## Release Notes

# Hardware Change Ranger<sup>®</sup>/RG 2200, 2300 and Spectra<sup>™</sup>/SP3022 Extender System Enclosures

**Document #:** 90-01262

**Version:** A01

*Figure 1 New Enclosure with one silver bracket installed*

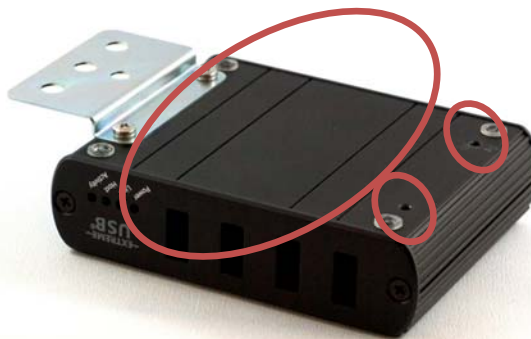
The bottom of the enclosure has been modified to include four screw holes for mounting brackets and a larger footprint space for customized labels.

It is important to note the while mounting holes have been added to the bottom of the enclosure, the overall dimensions and properties of the enclosure have not changed.

*Figure 3 New silver mounting brackets installed*

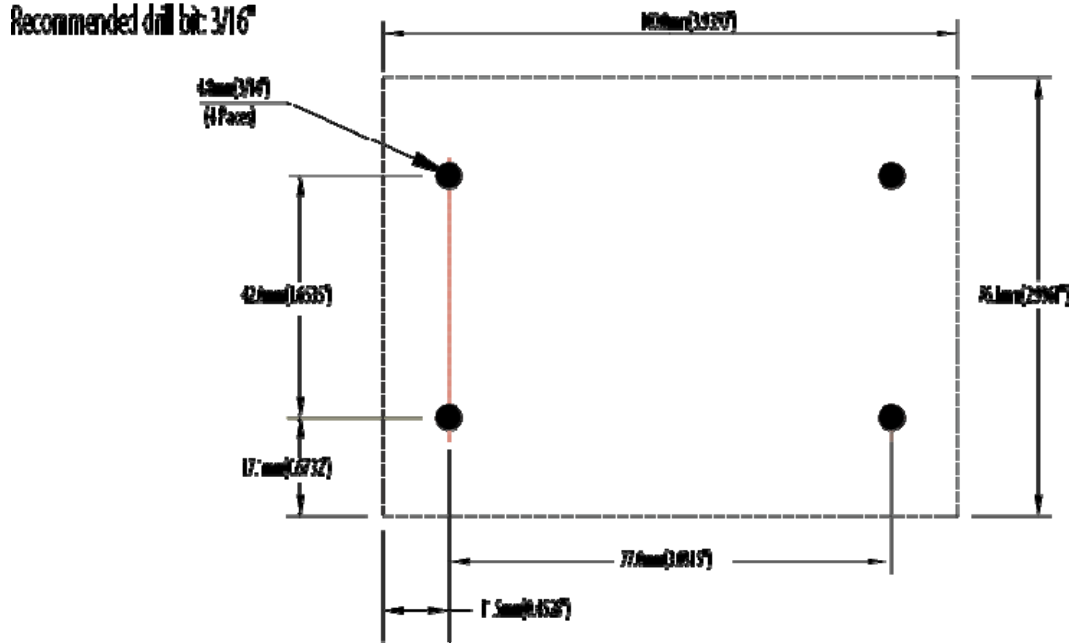
Old Mounting Bracket (“pressure mount”)	New Mounting Bracket
Part Number: 00-00268	Part Number: 10-00394 (black) 10-00406 (silver)

The original mounting brackets were a “pinch” or “pressure” mount style. They slid into a groove on the side of the enclosure, and then were screwed to a surface. These mounting brackets work well on solid surfaces such as platters, desks, walls, etc. however proved difficult if the dimensions of the mounting area were less than that of the enclosure.

The new mounting brackets are attached by screws to the bottom of the enclosure, thus allowing them to be mounted to any surface, whether spanning the entire width of the extender or not. Moreover, the screw holes are positioned to support standard 19” racks.
